3. CASE 23.027, 40 STIMSON AVENUE, Edward S. Clark House, 1892 (STIMSON)

Applicants/Owners: Robin & dan Halprin-Ruder, 40 Stimson Avenue, Providence, RI 02906

Proposal: The scope of work proposed consists of Major Alterations and includes:

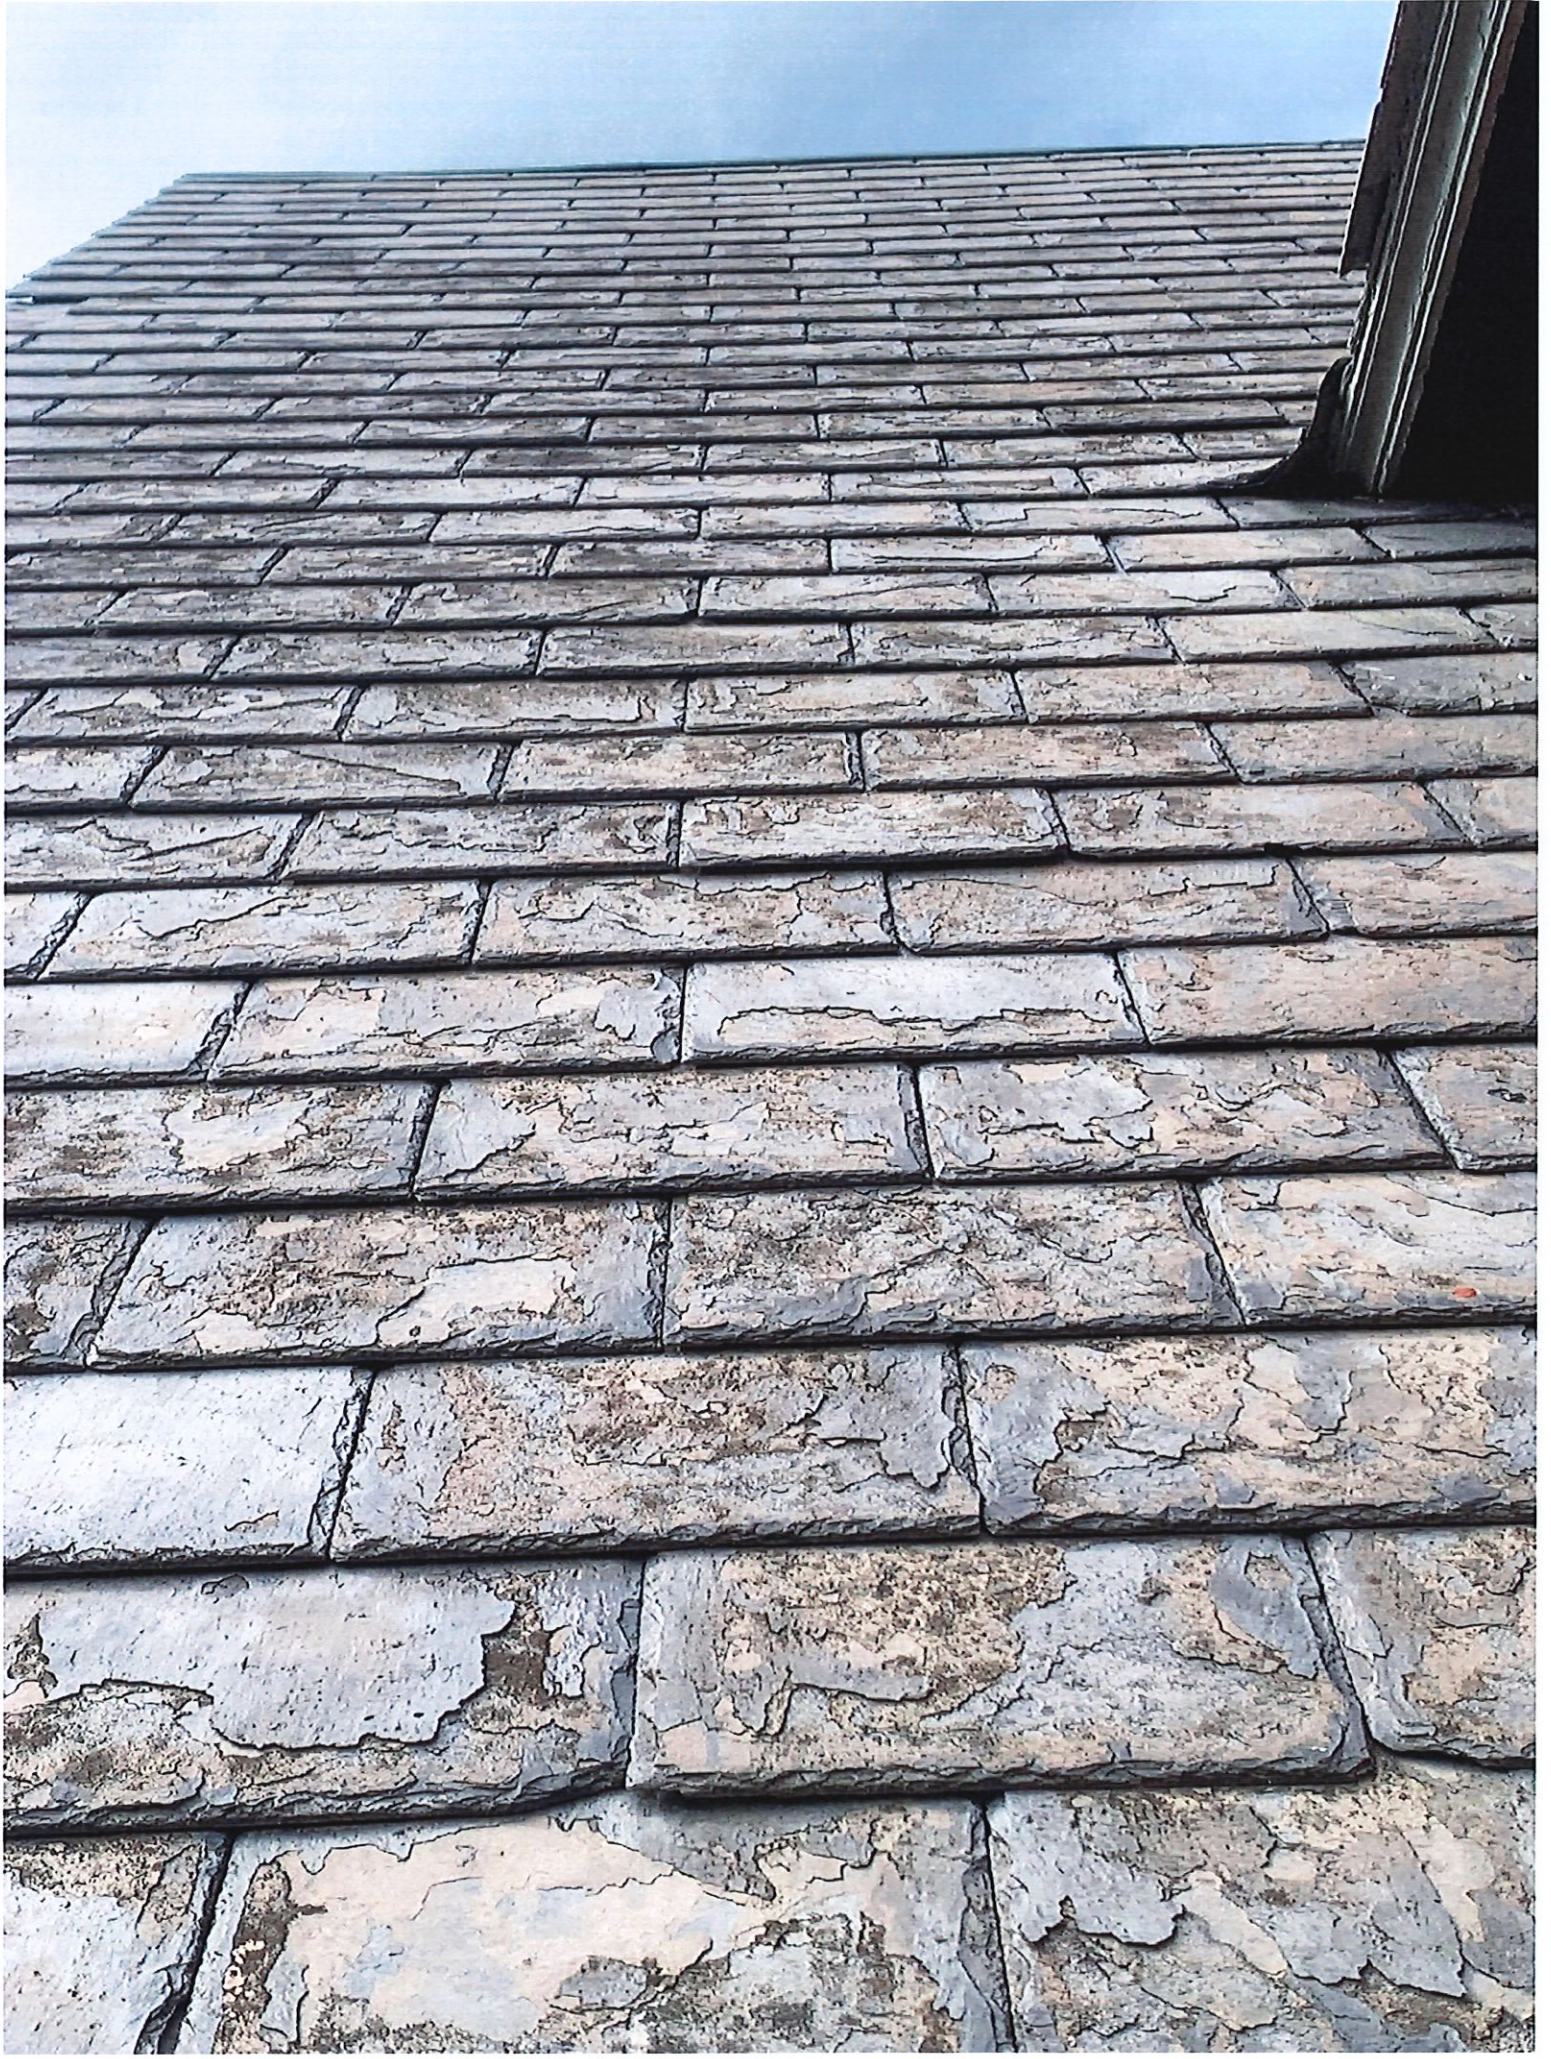
Gentlemen, I have inspected the slate roof at 40 Stimpson Street as requested. I have attached only a few photographs. It was obvious that the existing slate should be removed as soon as possible. Typically, Sea Green slate has a life expectancy of 100 years so has now failed with age. Unfortunately, the slates are soft, delaminating and shedding its layers. I found numerous pieces scattered on the ground. Please review the attached photos and feel free to call if you have any questions.
